# **Dollinger Corporation Site**

Site Number 8-28-078

# **Record of Decision**

### Department of Environmental Conservation Responsiveness Summary for Proposed Remedial Action Plan Dollinger Corporation Site #828078 Brighton, New York

Table 3

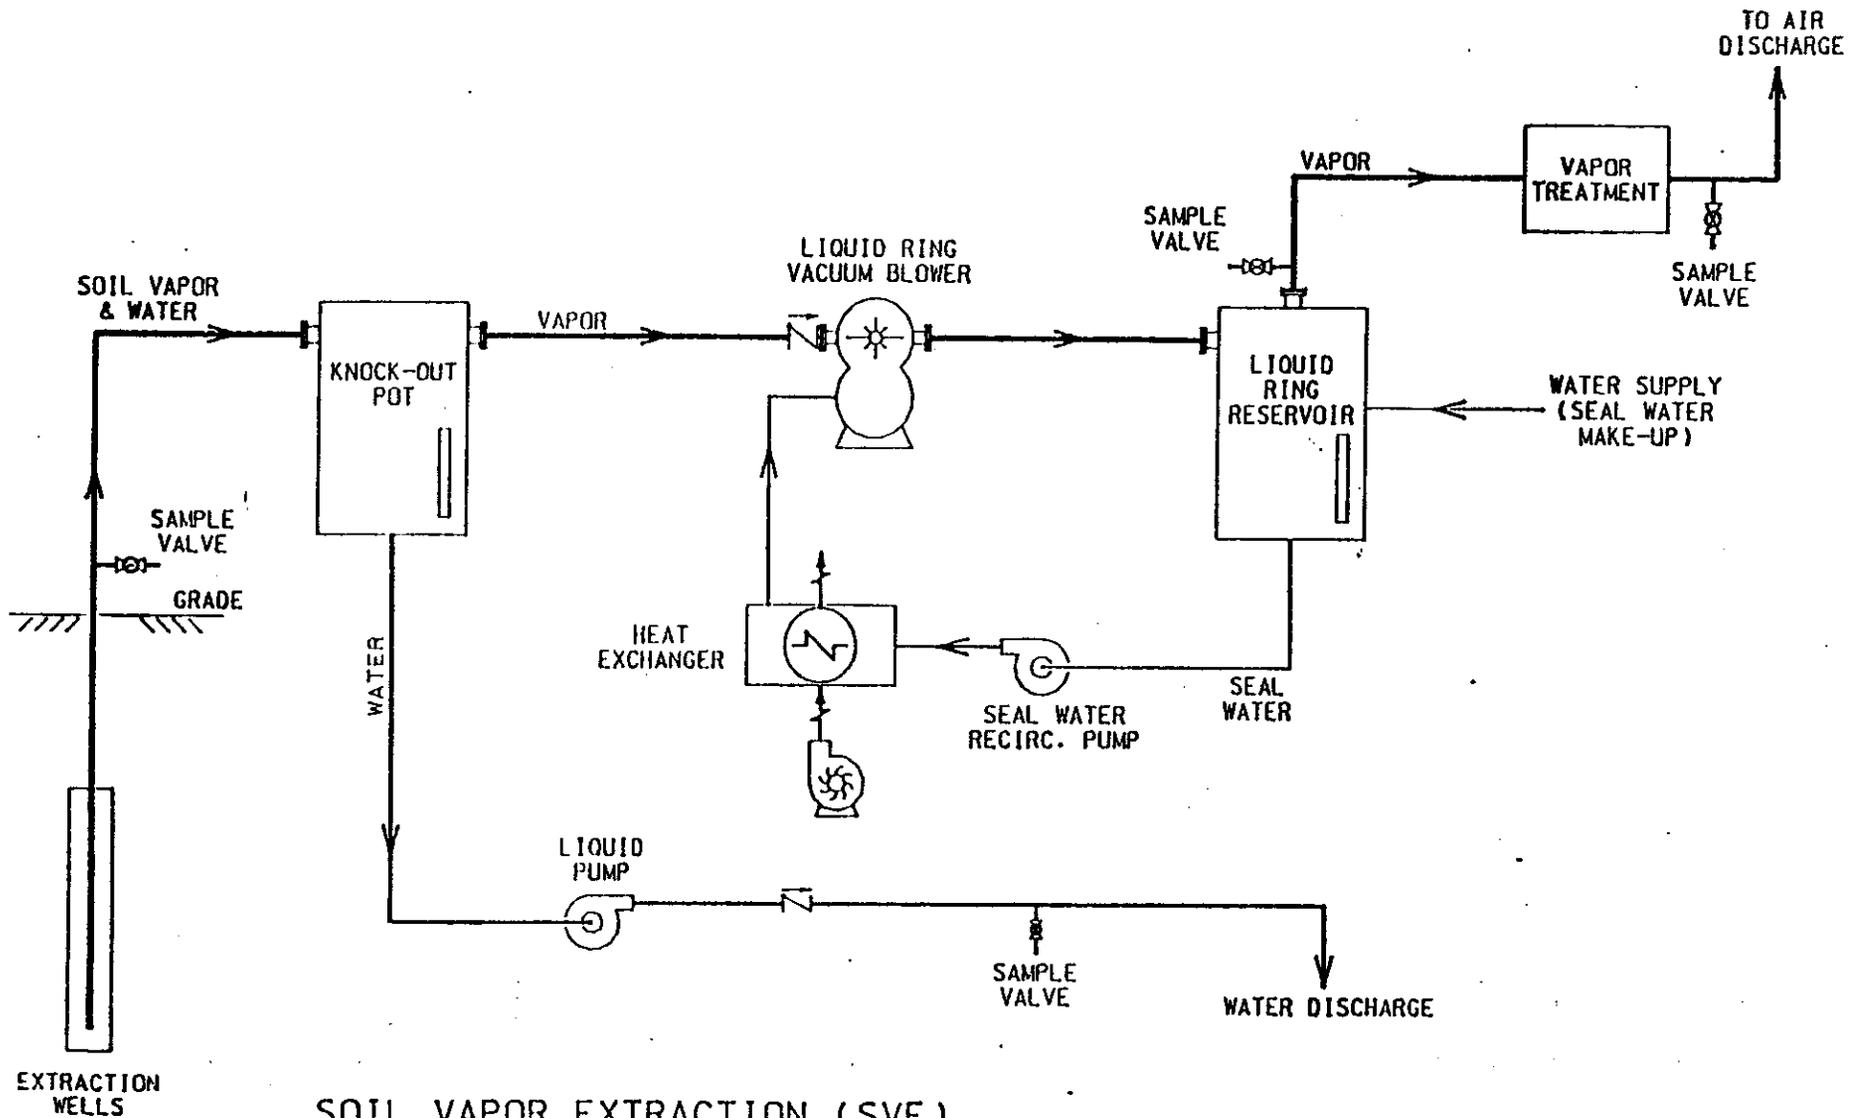
- Q: On Table 3 of the PRAP, the Department scored the bentonite collar contaminant migration control measure 15 out of a possible 20 points for the criteria "Overall Protection of Health and Environment." As shown on Table V and Appendix B of the FS, we scored this remedial measure 20 points under the same criteria. The first question in the evaluation, worth 20 points, is whether there will be unrestricted use of the site after the measure is implemented. Because the collar installation does not affect the use or appearance of the site land or water, we believe the response should be that there will be unrestricted use of the site after the measure is implemented, which response is assigned 20 points.

- Q: The Department also scored the bentonite collar contaminant migration control measure 0 for the criteria "Reduction of Toxicity, Mobility and Volume." In the FS, this measure was given a score of 5 because the method represents an irreversible method of immobilization (one question worth 5 points).

- Q: On Table 3 of the PRAP, the in-situ vacuum extraction remedial technology for groundwater shows scores of 14 and 13 for "Long Term Effectiveness" and "Reduction of Toxicity, Mobility and Volume", respectively. Although these scores are the same as those in the detailed screening scoring sheets for groundwater provided in Addendum II of the FS, the following footnote qualified the scores assigned to both criteria: "In light of the low permeability of site soils, it is currently unclear how effectively the SVE system will remove VOCs from the limited source area groundwater."

- A: The Department agrees that the score of 15 out of a possible 20 points for the above-mentioned criteria was incorrect. The correct total in our evaluation should be 16 out of 20 for the following reasons:

- A: It is the Department's view that the bentonite collars are a containment technology and therefore cannot be considered as an irreversible reduction in contaminant mobility. As such, the Department score Analysis Factor 3 zero points and therefore, the total point score for the criteria would be 0. Further, the Department has proposed the use of collars as part of the proposed remedial plan and as such, any increase or decrease in the score for this alternative is irrelevant as the action is already part of the proposed remedy.

- A: The Department has re-evaluated the cost estimate for excavation and off-site disposal. The cost estimate presented in Table 3 of the PRAP was for excavation and land disposal of contaminated soils outside of the footprint of the building. This is also the assumption of the cost estimate provide by the questionner. The Department believes that both estimates are misleading because partial excavation of the source area (outside the building footprint) would be an inadequate source remediation. Further, the Department maintains that excavation under the building footprint is technically feasible.

- As such, the Department has revised the cost estimate presented in Table 3 for excavation and off-site disposal, to the low end of the cost estimate provided by H&A of New York in the Feasibility Study, Addendum I. The new estimate of excavation and off-site disposal is \$5.25 million.

- A: Comment noted. This statement was considered in the PRAP when the Department provided the statement on page 6 that "it is recognized by the Department that in light of the low permeability, soil vapor extraction is an innovative approach." We recognize that the SVE system may not be totally effective and as such, have incorporated mechanisms to evaluate the remedy should the SVE system fail to meet cleanup objectives.
